Landscape and Visual Appraisal

Addendum 4

Sheringham Recycling Centre

April 2024

Drawing 2735_00_201 Landscape Mitigation Plan (Revision N)

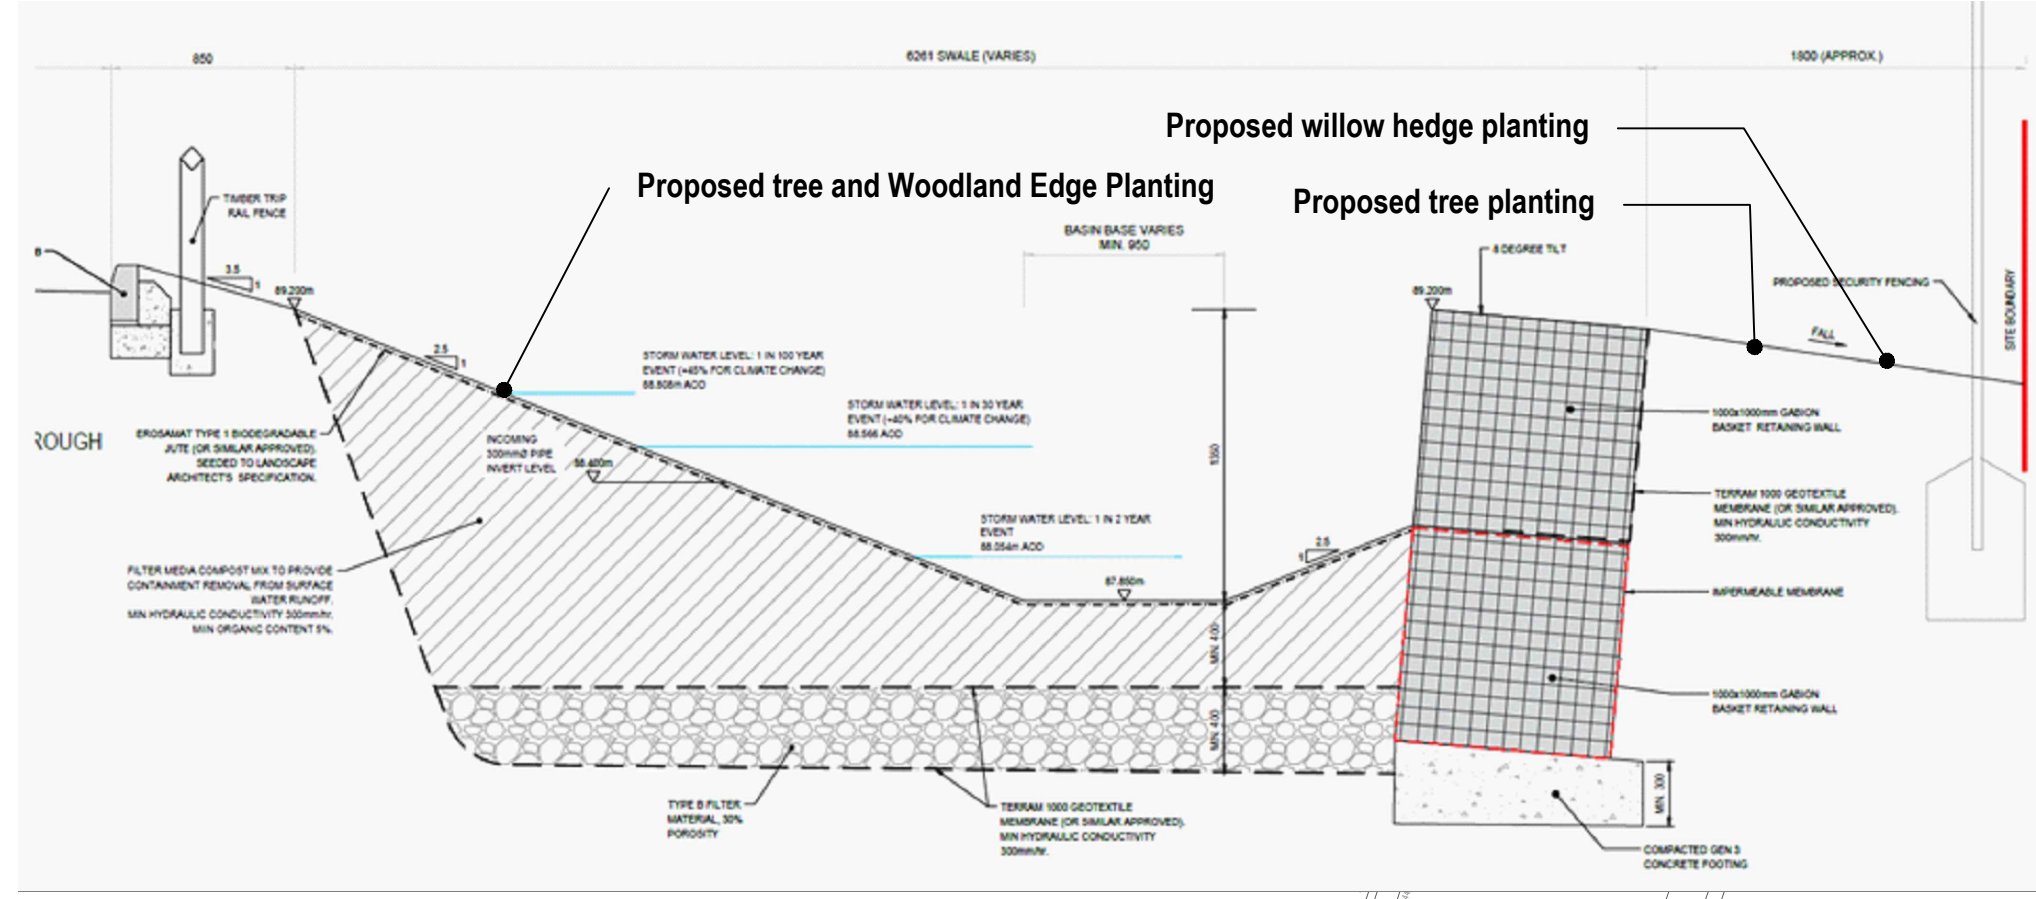
- 5.1 Drawing 2735_00_201 Landscape Mitigation Plan (Revision N), Appendix A illustrates the proposed changes covered by this Addendum, which address planning comments relating to screening of the Site, summarised here:

5.1.1 **Revision of planting along the internal east boundary to improve screening**

The species mix, number and size of trees along this boundary has been changed to ensure evergreen canopies provide improved year-round screening. These now comprise standard and Light Standard specimens including holly, holm oak and pine and the larger specification will contribute improved maturity to the new planting. The increased number of trees now totalling 16 specimens.

In addition, a new willow hedge will be planting against the eastern perimeter security fence adding an extra layer of fast-growing screening specified to reach 2.5m at maturity.

5.1.2 **Additional woodland planting within the area between Holt Rd and the RC;**

The area of vegetation between Holt Rd and the Development has been specified as planting with two different woodland combinations are proposed that will provide plants of differing species and sizes to create a more natural effect as the plants grow to maturity.

5.1.3 Adjustment to verge planting to accommodate underground services and create improved visibility splays;

In addressing the additional screening we were mindful of the need for clear visibility for vehicles leaving the Site. A 2m verge has been proposed and this will be planted with a species rich grass mix that will allow drivers to have a clear view of Holt Rd in both directions. In addition, a similar technique has been used at the eastern end of this new planting zone to ensure vehicles using the farm track will have clear site lines.

5.1.4 Additional planting to soften security fencing to the north and west boundaries and replacing willow hedge with living willow acoustic screens;

The style of boundary planting has been revised to the north and west perimeters. To provide sufficient acoustic protection as well as security, these boundaries now comprise 2.5m high acoustic living willow panels on the inside of perimeter chain link and barbed wire fence.

5.1.5 Minor planting adjustments to the internal south boundary to accommodate service easements and improve visibility as drivers leave the facility.

To ensure easement of underground services running along the internal southern boundary of the Site, minor adjustments have been made to the position of the new trees and the hedgerow at the western side of this area.
